MOD2020/0049

SCHEDULE OF MODIFICATIONS SOUGHT

PROJECT ADDRESS
98 CUTLER ROAD,
CLONTARF

CLIENT
BOWES HOUSE

SECTION 1
1 : 100

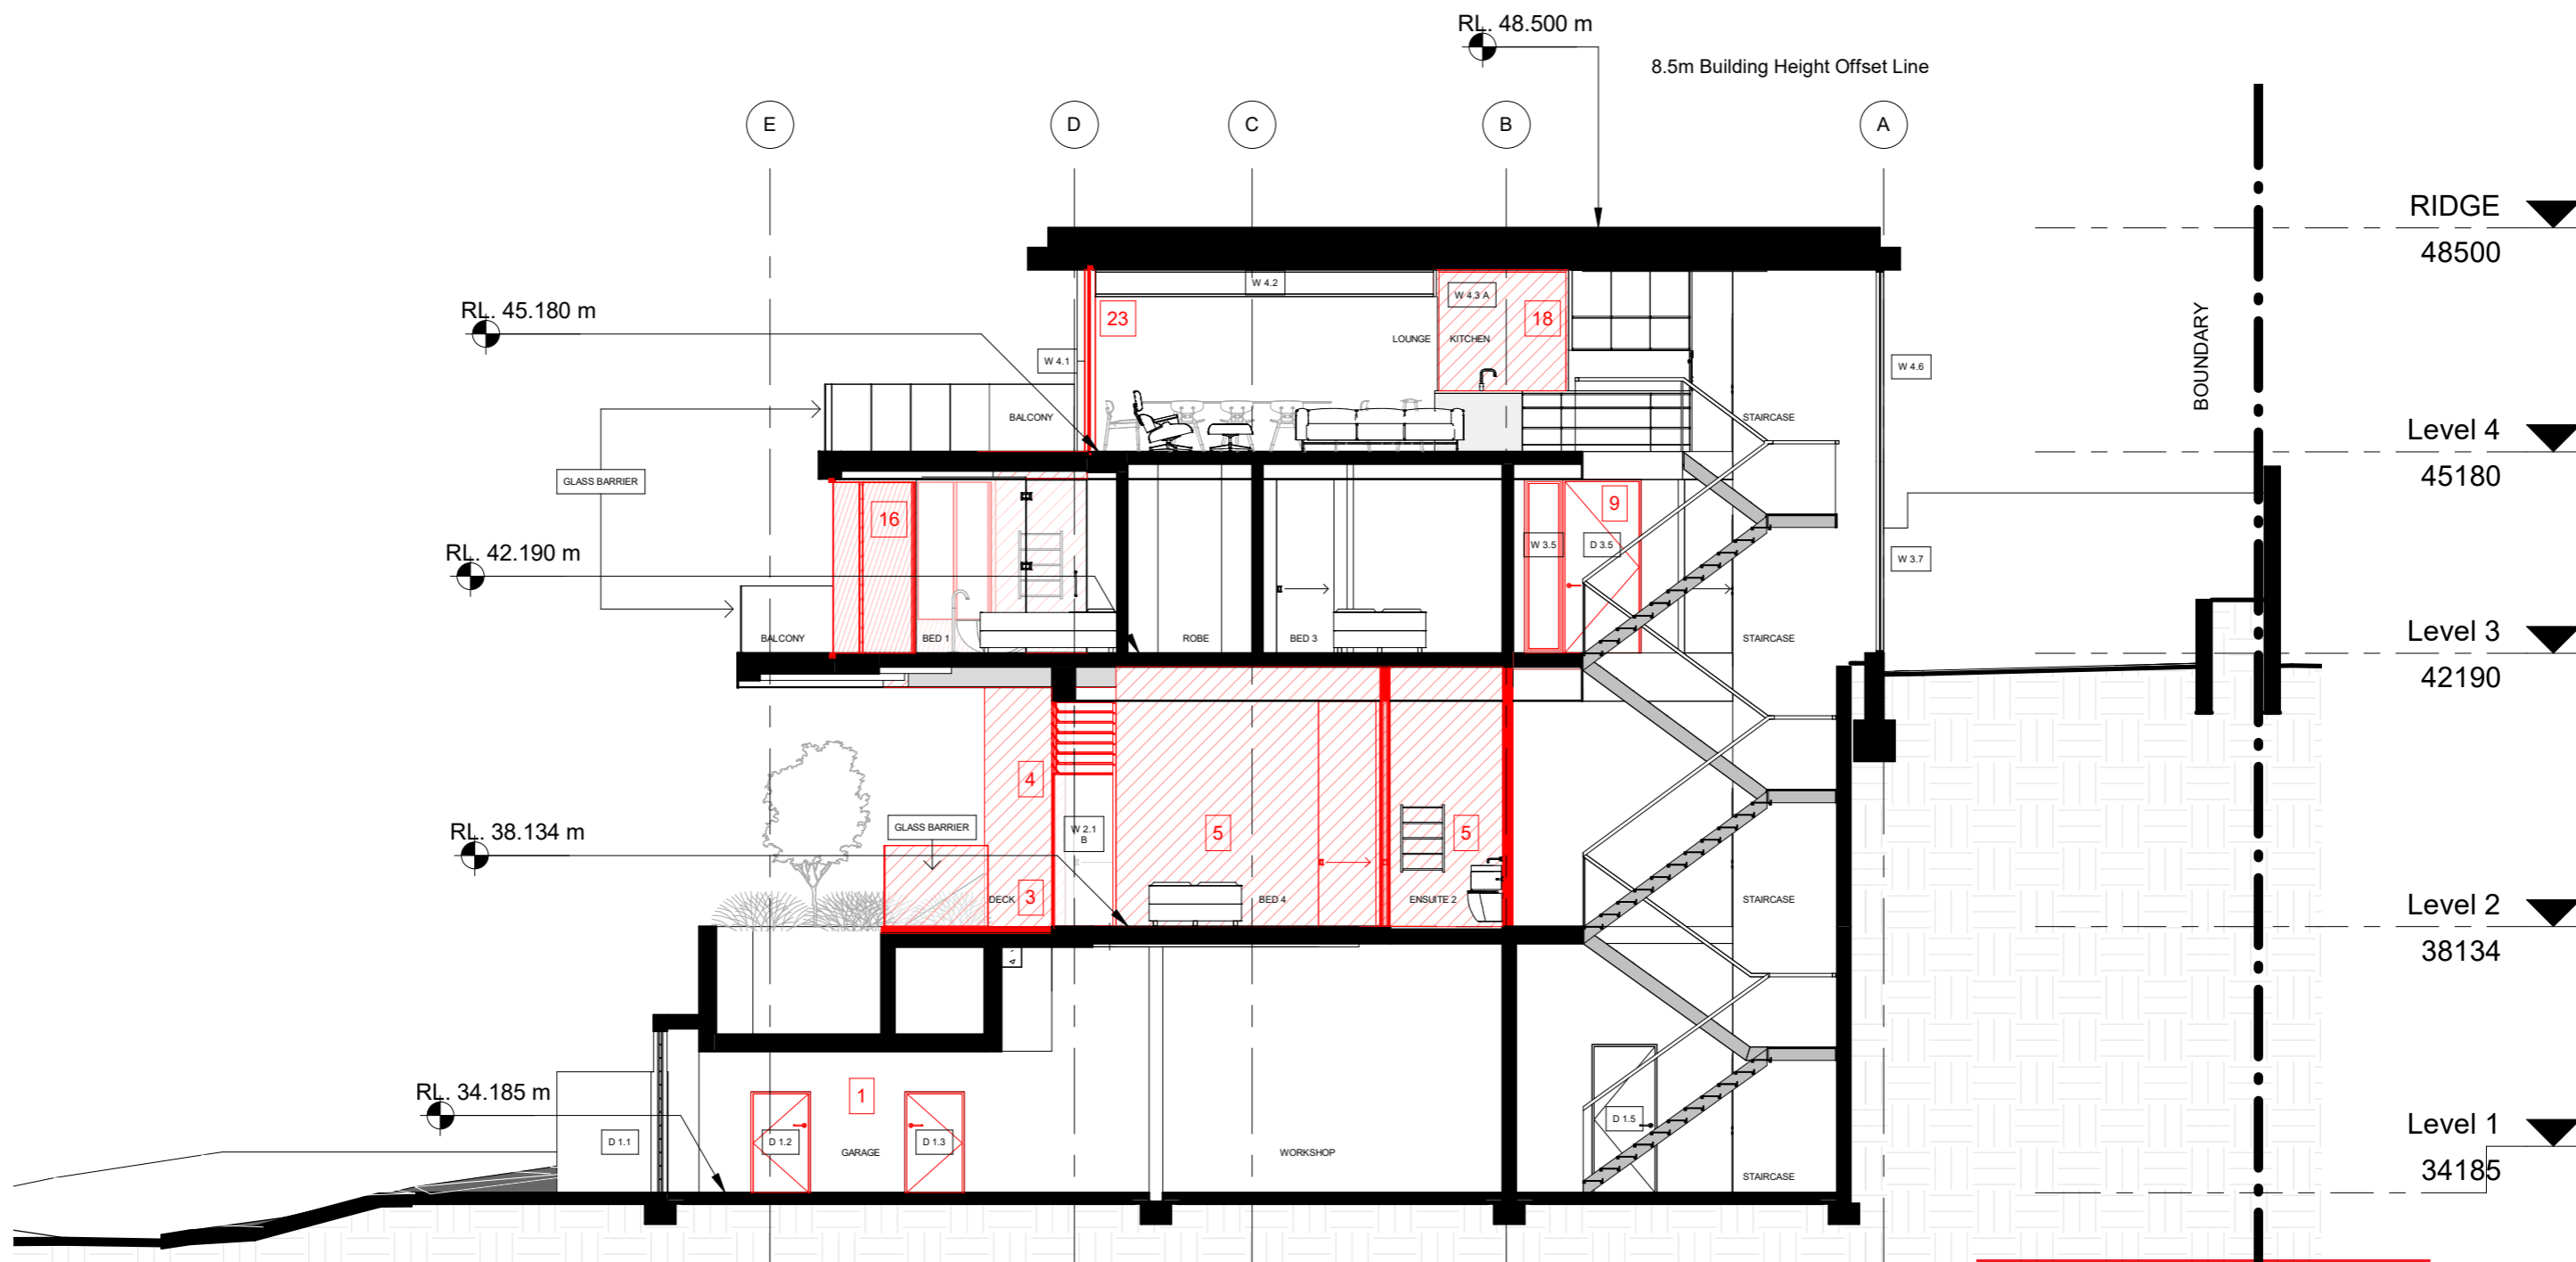
SCHEDULE OF MODIFICATIONS SOUGHT	LEVEL 3 MODIFICATIONS	LEVEL 4 MODIFICATIONS
<p>LEVEL 1 MODIFICATIONS</p> <ul style="list-style-type: none"> 1. Proposed storage space 2.1 Proposed front boundary security gate 2.2 Gas - Electric and water meter <p>LEVEL 2 MODIFICATIONS</p> <ul style="list-style-type: none"> 3. Modified Deck adjacent to suspended landscape garden & glass barrier. 4. Proposed structural blade wall 5. Proposed modified floor layout including additional bedroom and associated windows 6. Proposed ensuite 3 and associated windows 6.1 Structural column 	<ul style="list-style-type: none"> 7. Modified floor area to ensuite 1 and associated windows 8. Modified windows to Bed 2 9. Modified door and side-light height 10. Replace Bi-fold doors with window 3.6 11. Window location modified 12. Proposed external door 13. Proposed increase to Bed 3 floor area 14. Modified window height 15. Modified window height 15.1 Modified bedroom area 16. Modified Door heights 16.1 Concrete slab above entry 	<ul style="list-style-type: none"> 17. Extend terrace 18. Proposed additional floor area to kitchen - modified kitchen windows 19. Modified pantry window 20. Modified pantry window 21. Remove existing chimney 22. Modified window height 23. Modified door height

1 SECTION 2
1 : 100

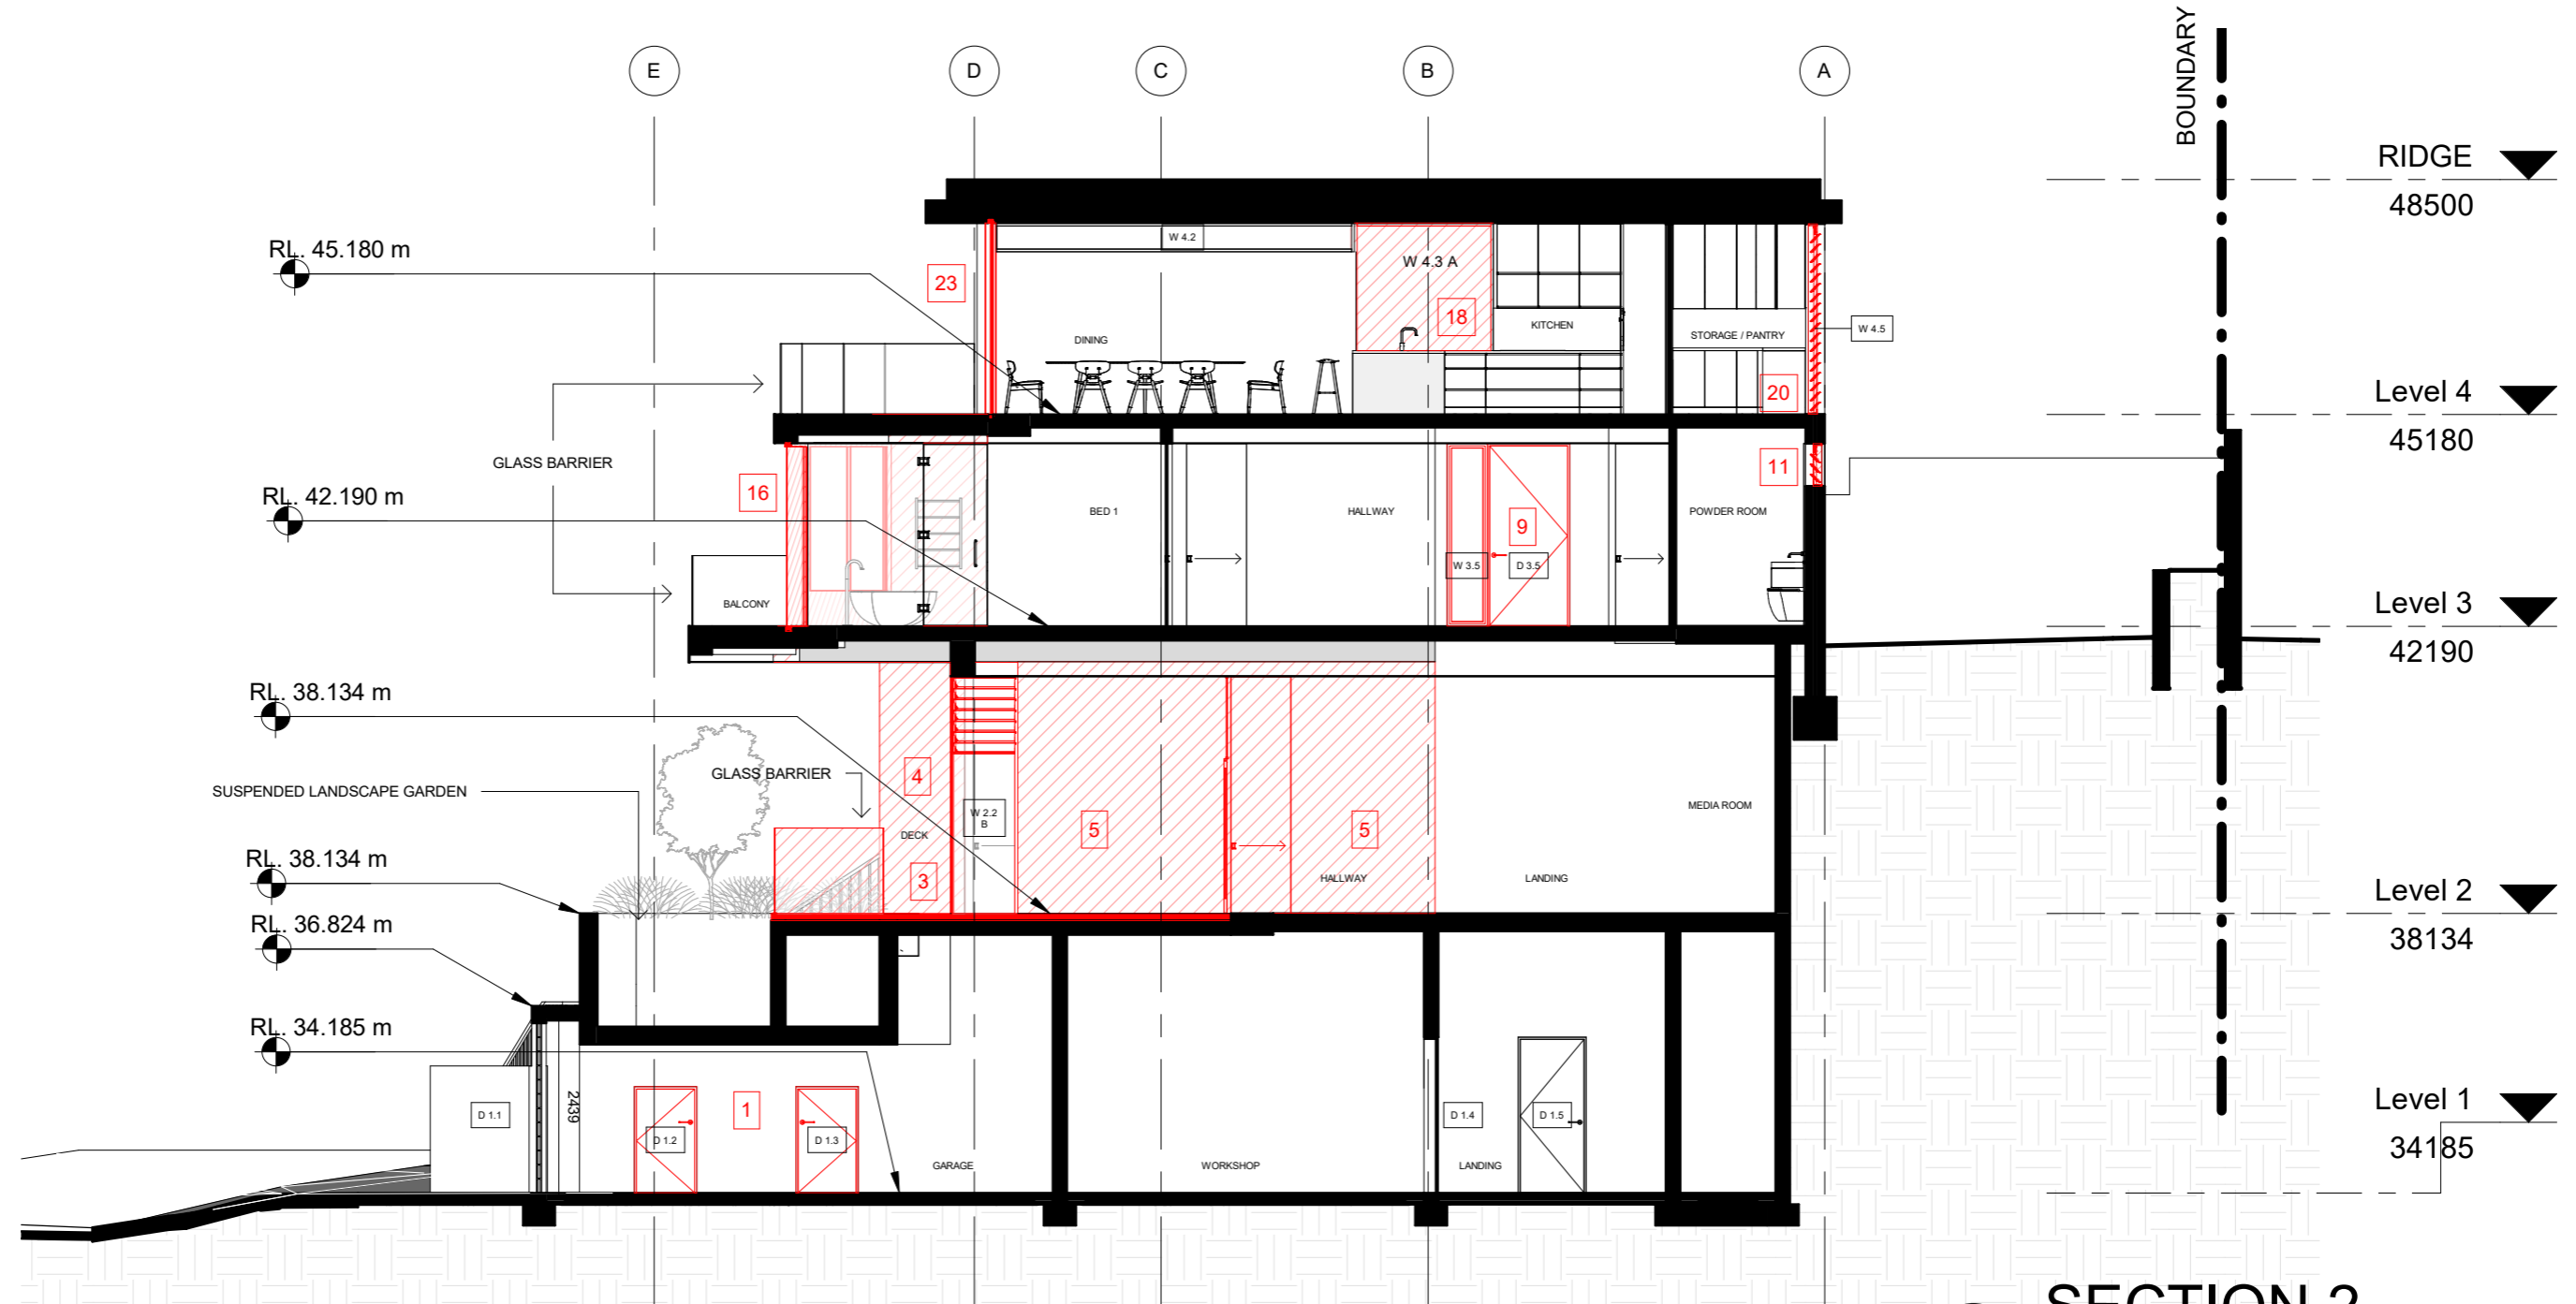
SCHEDULE OF MODIFICATIONS SOUGHT	LEVEL 3 MODIFICATIONS	LEVEL 4 MODIFICATIONS
LEVEL 1 MODIFICATIONS 1. Proposed storage space 2.1 Proposed front boundary security gate 2.2 Gas - Electric and water meter LEVEL 2 MODIFICATIONS 3. Modified Deck adjacent to suspended landscape garden & glass barrier. 4. Proposed structural blade wall 5. Proposed modified floor layout including additional bedroom and associated windows 6. Proposed ensuite 3 and associated windows 6.1 Structural column	7. Modified floor area to ensuite 1 and associated windows 8. Modified windows to Bed 2 9. Modified door and side-light height 10. Replace Bi-fold doors with window 3.6 11. Window location modified 12. Proposed external door 13. Proposed increase to Bed 3 floor area 14. Modified window height 15. Modified window height 15.1 Modified bedroom area 16. Modified Door heights 16.1 Concrete slab above entry	17. Extend terrace 18. Proposed additional floor area to kitchen + modified kitchen windows 19. Modified pantry window 20. Modified pantry window 21. Remove existing chimney 22. Modified window height 23. Modified door height

SECTION 3

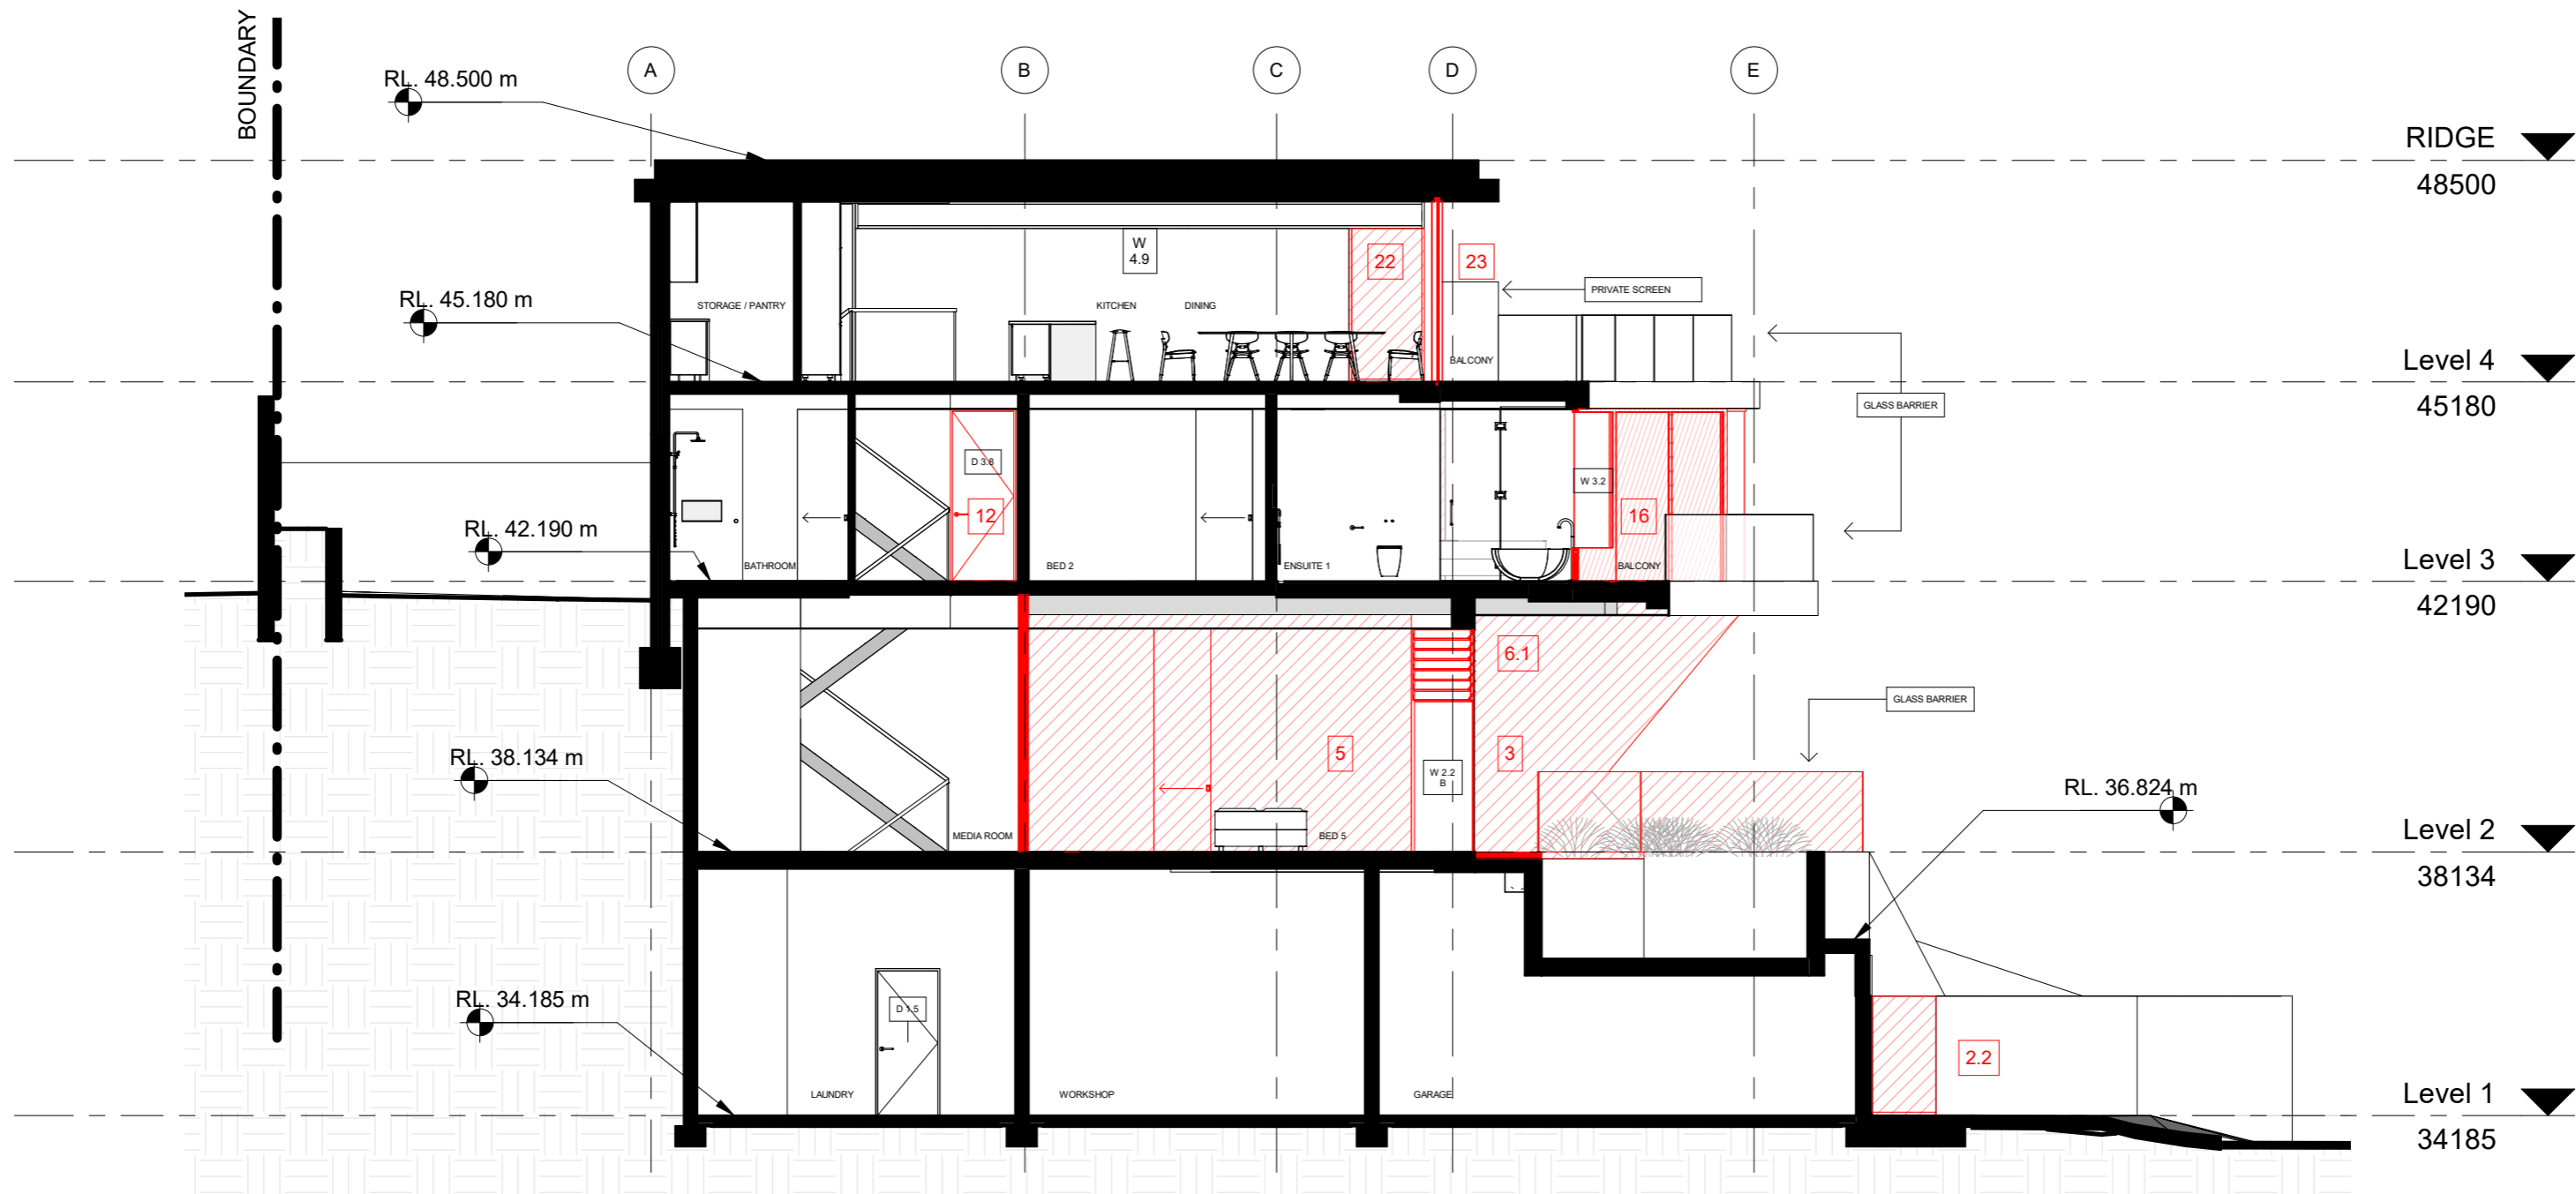
SCHEDULE OF MODIFICATIONS SOUGHT	LEVEL 3 MODIFICATIONS	LEVEL 4 MODIFICATIONS
LEVEL 1 MODIFICATIONS 1. Proposed storage space 2.1 Proposed front boundary security gate 2.2 Gas - Electric and water meter LEVEL 2 MODIFICATIONS 3. Modified Deck adjacent to suspended landscape garden & glass barrier. 4. Proposed structural blade wall 5. Proposed modified floor layout including additional bedroom and associated windows 6. Proposed ensuite 3 and associated windows 6.1 Structural column	7. Modified floor area to ensuite 1 and associated windows 8. Modified windows to Bed 2 9. Modified door and side-light height 10. Replace Bi-fold doors with window 3.6 11. Window location modified 12. Proposed external door 13. Proposed increase to Bed 3 floor area 14. Modified window height 15. Modified window height 15.1 Modified bedroom area 16. Modified Door heights 16.1 Concrete slab above entry	17. Extend terrace 18. Proposed additional floor area to kitchen + modified kitchen windows 19. Modified pantry window 20. Modified pantry window 21. Remove existing chimney 22. Modified window height 23. Modified door height
